# SERVICE INFORMATION BULLETIN

APPLICABILITY: **NUMBER:** 07-154-19 2014-18MY Forester

SUBJECT: DTC B2513, Revised Power Rear Gate (PRG) **DATE:** 05/28/19

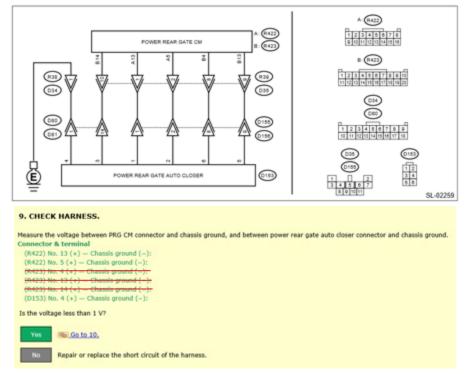
This Service Information bulletin provides a revised Step to follow when diagnosing a DTC B2513-LATCH CONDITION FAILURE. The number of wiring checks found in Step 9 has been reduced from six to three as shown in the illustration below. The Service Manual will be updated with these revisions in the near future.
